CITY OF ALBUQUERQUE

Re: Solare Charter School, Phase 1
8801 Gibson Blvd SW
Request for Certificate of Occupancy
Transportation Development Final Inspection
Engineer's/Architect's Stamp dated 6-17-19 (M09D031)
Certification dated 2-20-20

PROJECT
SOLARE CHARTER SCHOOL
8801 Gibson Blvd. SW
Albuquerque, NM 87121
TITLE
Traffic Control Layout

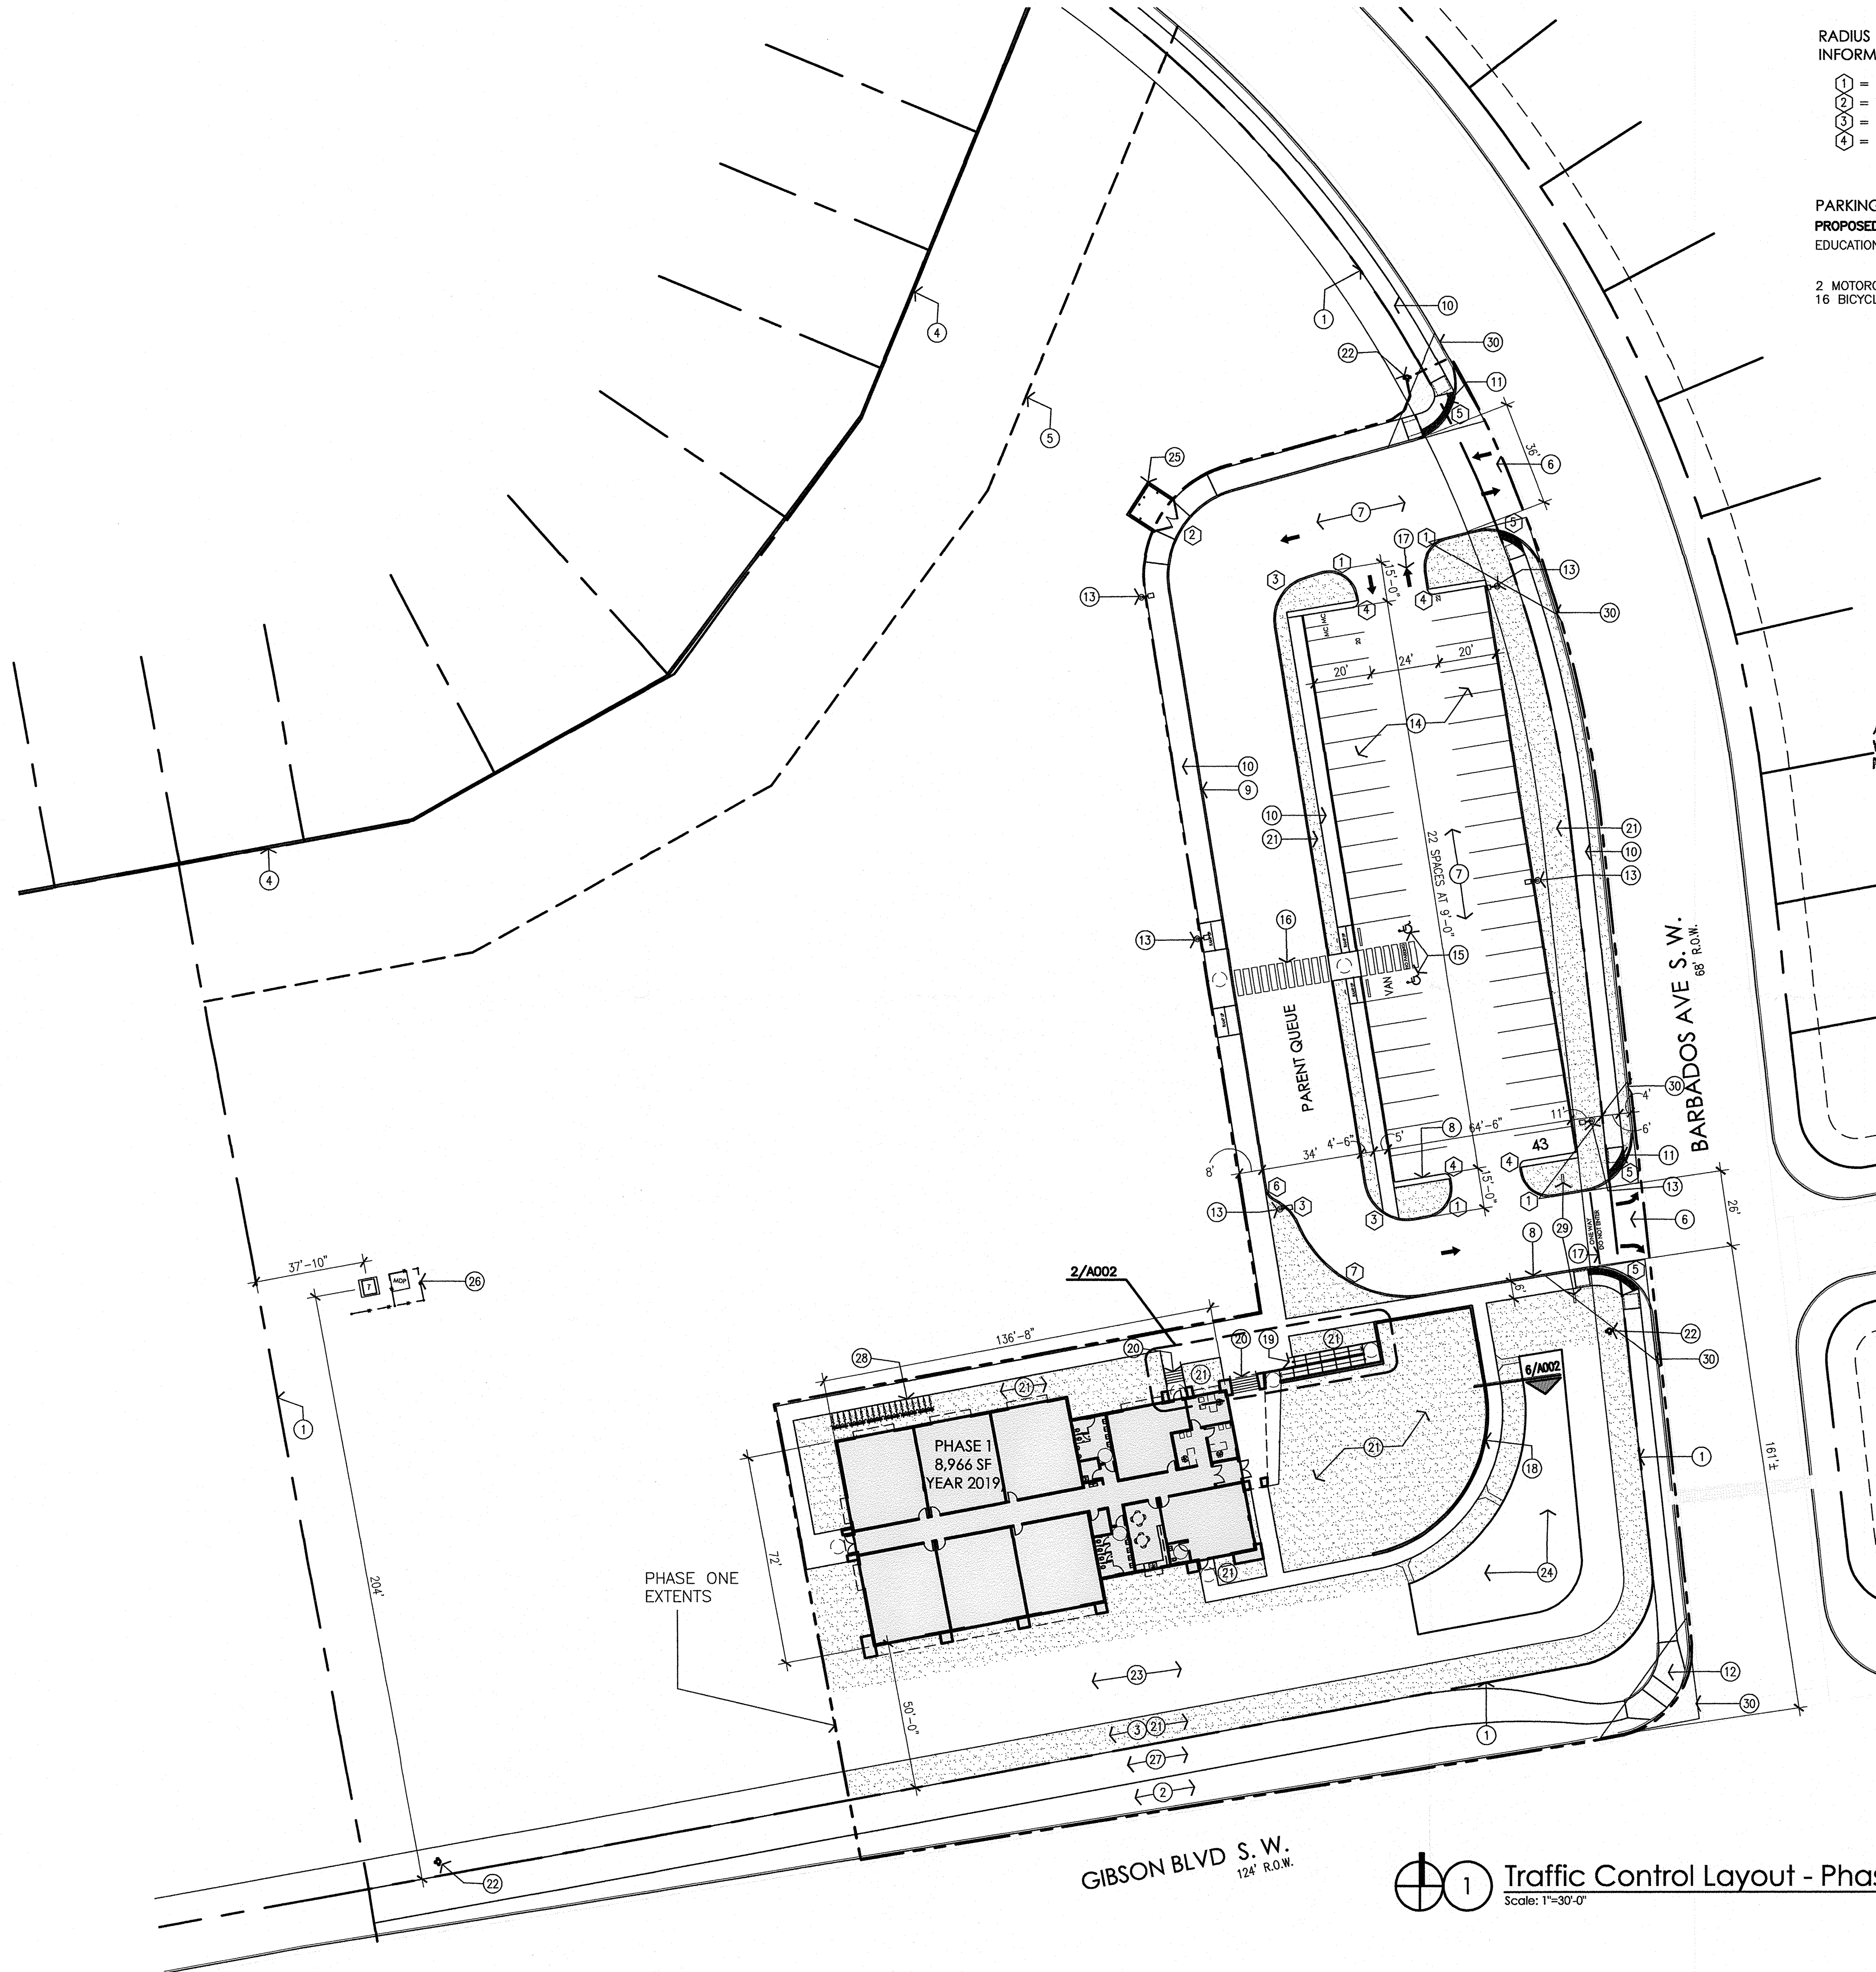
- Please complete bike trail keynote #27.
- Pending Hydrology Approval.

The attached Traffic Control Layout shows the "redlined" minor revisions made to the plan during construction. The revisions include moving the required bike racks for better access, shifting light poles, and adjusting pavement markings.
